NAME	PQ-3220 (4P)	MATERIAL	PM-9820	SCALE	1.2:1	ANGLE	$\pm 1^\circ$
DRAWING NO.	HX 3205	PIN MATERIAL	CP WIRE	UNIT	m/m	REV.	02
<p>东莞市华欣塑胶制品有限公司 DONGGUAN HUAXIN PLASTIC MANUFACTURING PRODUCTS CO., LTD. TEL: 0769-86388088 86388188 86388288 FAX: 0769-86388111 http://www.hxbobbin.com E-Mail: hxbobbin@vip.163.com</p>		TOLERANCE OF PIN DIA ± 0.05				PIN TENSION LOAD 1.5 kg MIN	
		TOLERANCE: $0 < L < 4: \pm 0.1$ $4 < L < 16: \pm 0.2$ $16 < L < 63: \pm 0.3$				UL REC.: 94V0	
DRAWN & DRAFTED BY		LIN HUA JING		CHECKED & APPROVED BY		DATE: NOV 26 2012

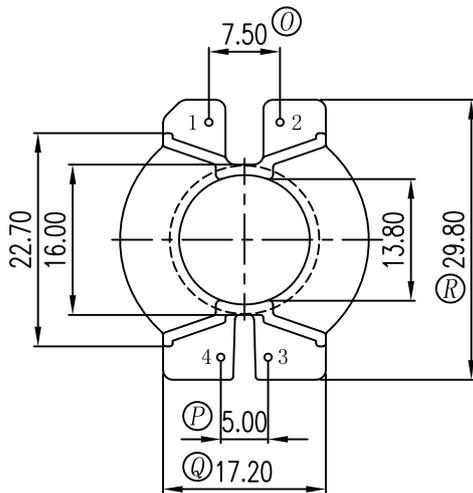
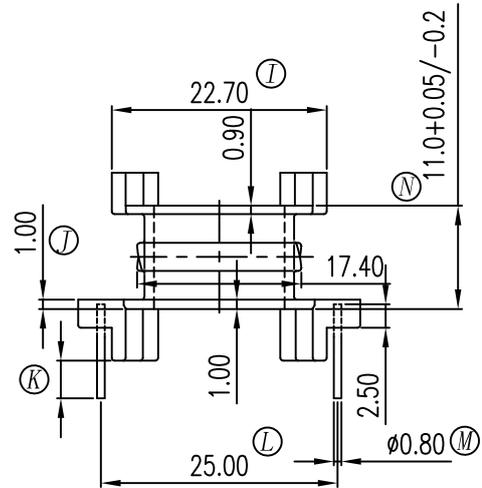
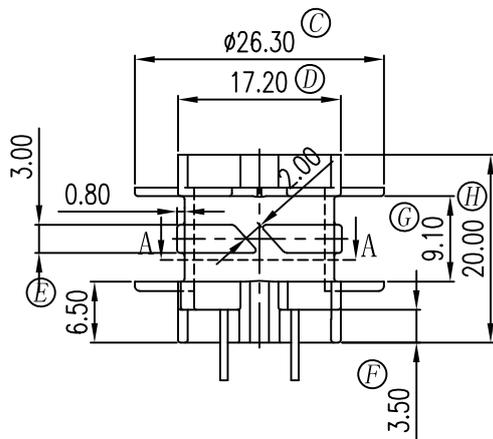
REV.	REVISION RECORD	DATE	REV	REVISION RECORD	DATE
01	1. 繞線區中間加3.0VDE。	2012/11/02	03		
02	1. F尺寸由2.50改為3.50, 總高度不變; PIN3, 4邊TOP部V形缺口改為方形缺口	2012/11/26	04
